## ADDENDUM NO. 1

Reference: South Hangar Rooftop Unit Replacement – West Jordan AASF  
Utah National Guard – West Jordan, Utah  
DFCM Project No. 09161480

Project Name: UNG AASF South Hanger AC Upgrade

Addendum No.: 1

## ROOF TOP GUARD RAIL DETAIL - OPTION #2

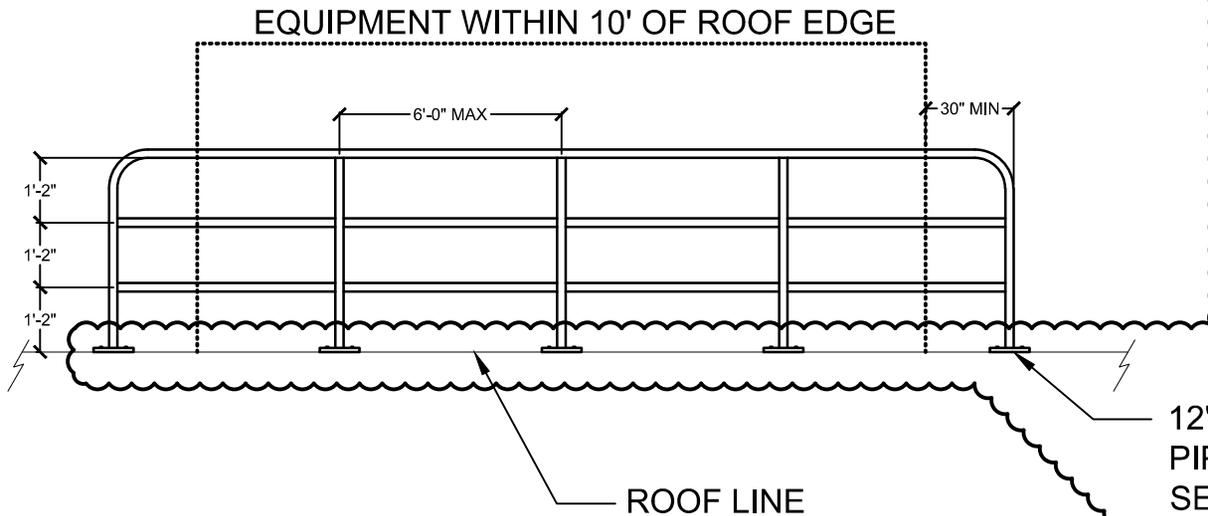
**Item IV-2.** – Modified detail B4 on ME502 to mount guard rail to roof. Provide roofing modifications as necessary. Use a roofing contractor from the most current DFCM short list of roofers. List is available for download at [www.dfc.utah.gov](http://www.dfc.utah.gov). See attached sketch ADD1A.

**NOTE:**  
 PROVIDE ROOF MODIFICATIONS  
 TO ACCOMMODATE NEW ROOF  
 RAIL SUPPORTS. ROOFING  
 MODIFICATIONS SHALL BE  
 PROVIDED BY ROOFING  
 CONTRACTOR ON MOST  
 CURRENT DFCM SHORT LIST.

12"x12"x3/8" STEEL PLATE, WELD TO  
 PIPE. ANCHOR TO ROOF. PATCH AND  
 SEAL AT ROOF.
